Monitoring Report

Harrell Stream and Wetland Mitigation Site

Monitoring Year 1-2020

Subject: MY1 Monitoring Report (Task 6)
Harrell Stream & Wetland Site, Jackson County
Little Tennessee River Basin – CU 06010203 – Jackson County
DMS Project ID No. 100005
DEQ Contract #007006

XS Number: 5
XS Type: Riffle

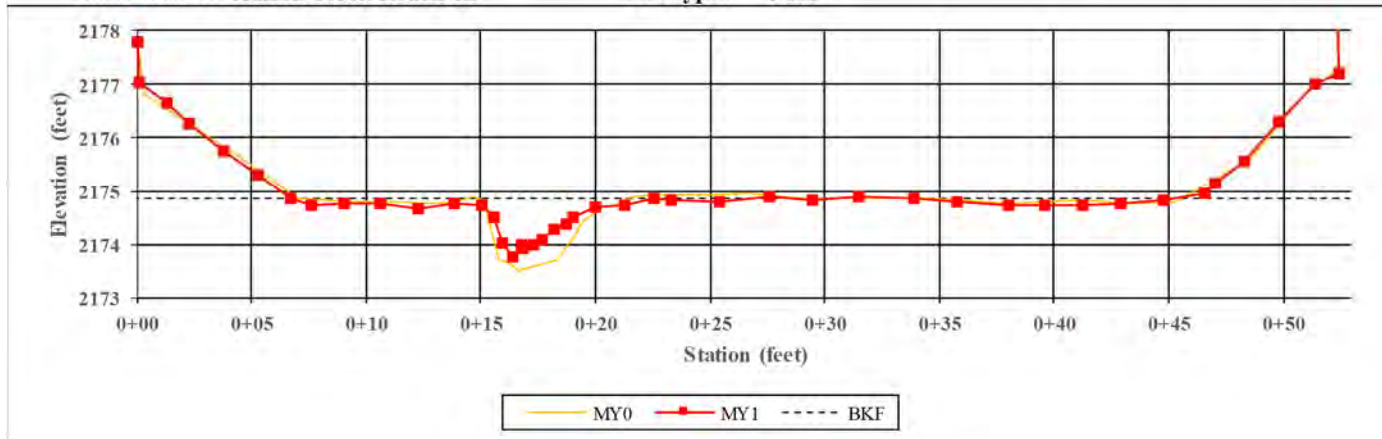
Section 1.5.2 – Stream Geomorphology (Reach 1D): Based on the Reach 1D photos provided and cross section 5, does EW Solutions have any concerns about this reach maintaining bed and bank stream features through the monitoring term? Please note that the IRT has historically required that mitigation project streams maintain jurisdictional bed and bank features for stream mitigation credit. DMS understands that EW Solutions has worked with NCDOT to keep the downstream culvert clear. These efforts should also be reported in the text. Please consider, discuss and update the report text accordingly. **EWS understands the concerns related to Reach 1D. Our primary concern is clogging of the DOT Culvert which has been monitored by both NCDOT and Equinox staff. MY1 data suggests stability within Reach 1D.**

- In the revised support files, please submit a set of features that characterize the IRT approved mitigation plan asset features. **A line feature class characterizing the IRT approved mitigation plan stream assets is included in the support file. Wetland polygon feature classes representative of the IRT approved mitigation plan assets are also included.**
- Please submit photo point features attributed with their unique ID's. **Updated and added to the digital support files.**
- Please review the cross-section data. It looks like for several cross sections the entries for low top of bank did not change from MY0 and MY1, but there is no specific point in the MY1 figure representing the low top of bank (e.g. XS2 vs. XS5). Also note that the "Omit Bkf" boxes were not checked for XS5,

resulting in an inaccurate BHR. Please review, update and revise the support files, report text and figures accordingly. **Cross-section data reviewed and updated. Appropriate supporting files and report text edited to reflect changes to the geomorphologic calculations.**

Gauge ID: **MW5** Reported Growing Season Days: 191
 Total Number of Consecutive Days Water Table within 12 inches of Soil Surface: **6**
 Percentage of Growing Season Water Table within 12 inches of Soil Surface: **3%**

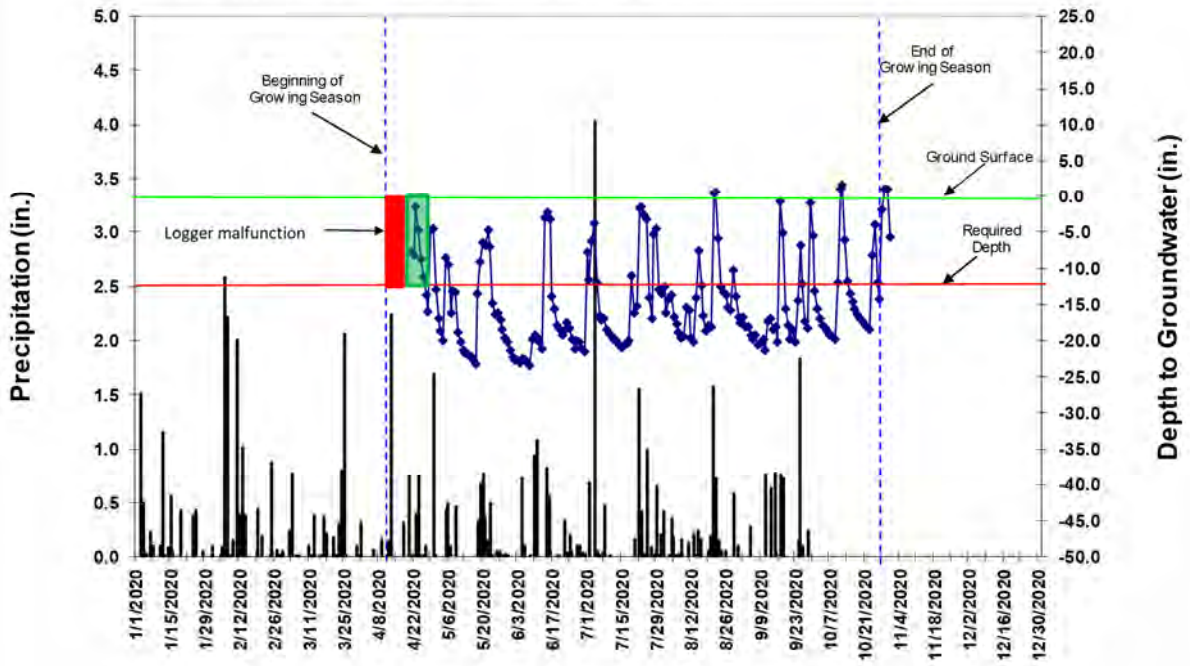
Section 1.5 Project Performance: Please provide an additional report Section summarizing and discussing the project's MY1 wetland performance and groundwater gauge data provided in the report Appendices. Any groundwater gauge malfunctions or issues should also be discussed in this section. Groundwater gauges 2, 5, and 7 did not meet the established 12% wetland hydrology success criteria in MY1. Based on the precipitation data provided, the site had an abnormally wet year; however, the project is only in MY1 of 7. Does EW Solutions believe that the site hydrology on the northern portion of the reestablishment area will improve over the monitoring term? Please consider, discuss and update the report text accordingly.

EWS understands the concerns regarding long term monitoring and the outcome for Wetland gauges 2, 5, and 7 hydroperiod success criteria. Upon revisiting the groundwater data to address comments, it was discovered a formula error had resulted in initially underreporting the success criteria for MW2. While currently meeting wetland criteria, MW2 remains at a marginal level. Our intent is to reconvene with project designers to determine what if any additional actions may be needed. We will confer with DMS after our discussion with the designers.
